Harbor Area Review Board

Meeting Agenda

Harbor Area Review Board Staff Report

From: Tom Bonadeo
Date: March 17, 2011
Item: Continued Review of Harbor Bath House
Attachments: Architectural Rendering and landscape drawings

CAPE CHARLES BATHHOUSE
RENDERED ELEVATIONS
03/14/2011

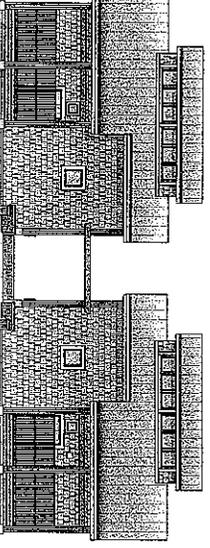
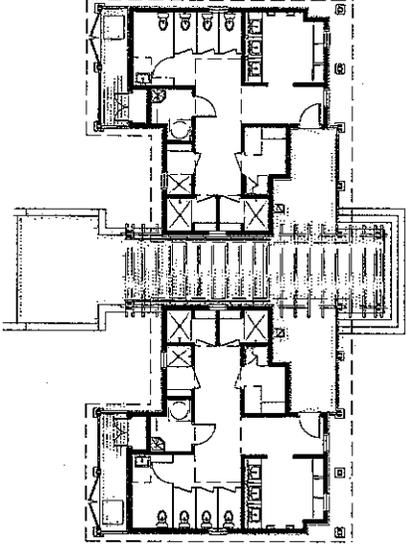
Tom Bonadeo noted that the diagram A2.1 showed square single-light windows and the Harbor Area Design Standards recommend rectangular windows similar to those currently in the buildings throughout the Town. Russ Dunton stated that these windows were for a bath house so we would probably not want a lot of windows. Tom Bonadeo stated that we could not dictate the type or size of the windows but could require they be vertically proportional with divided lights. Steve Bennett added that he was not opposed to square windows in a bath house. Laurie Klingel stated that the

single light window was more of an issue than the window being square since this was a bath house.

Laurie Klingel stated that she would like to see better detail for the exterior lights because it was difficult to determine whether the lights were on the exterior wall of the building or on the pagoda. Tom Bonadeo referred to a Light Plan, that was not distributed, which showed more detail. There was much discussion regarding the light fixtures and whether they had already been selected. Tom Bonadeo stated that it was unlikely that the exact light fixtures had been chosen but more likely just the style had been defined. Russ Dunton stated that it was not outlined in the guidelines that the Board had to approve individual fixtures. Steve Bennett reminded the Board that we were reviewing a completed plan and typically, there would not be this much detail provided during the application process. The application would probably have renderings vs. all the details.

Tom Bonadeo stated that he would request the architect provide the following: i) conceptual drawings in color; ii) landscape plan; iii) grading plan; iv) signage details; and v) the mortar color for the brick, and added that he would work on a color palette. Once the information had been received, Tom Bonadeo stated that he would deliver the information to the Board members to review prior to the next meeting. The Board would use the scale process to "grade" the project at the next meeting.
